UI Bulletin #106c

Subject: **Fuel Cap Tether Strap**

Models: Chevrolet Express/GMC Savana Cutaways with a service body installed

Date: December 13, 2012

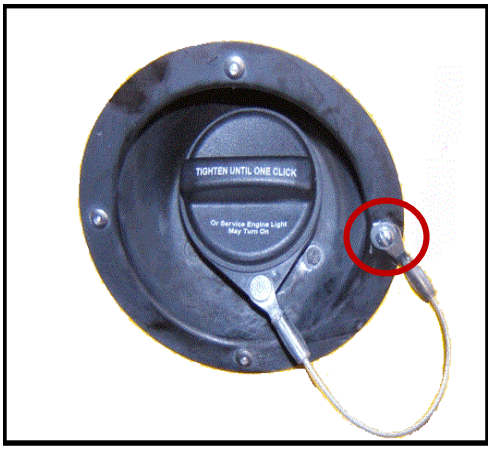
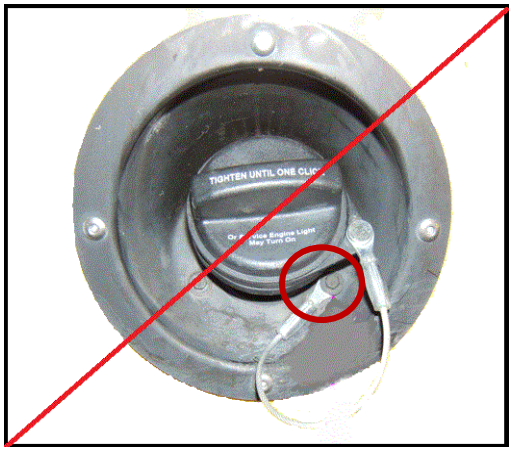
A condition may be caused by the fuel cap tether binding when installing the fuel cap and not allowing the fuel cap to seal completely or by the fuel cap tether being trapped between the fuel cap seal and the fuel fill pipe, not allowing the fuel cap to seal completely, possibly resulting in a Service Engine Soon Light being illuminated.

To avoid the above noted condition, all vehicles with a service body installed and using a stainless steel tethered fuel cap (9B4) should tether the cap as shown below.

This

Not This
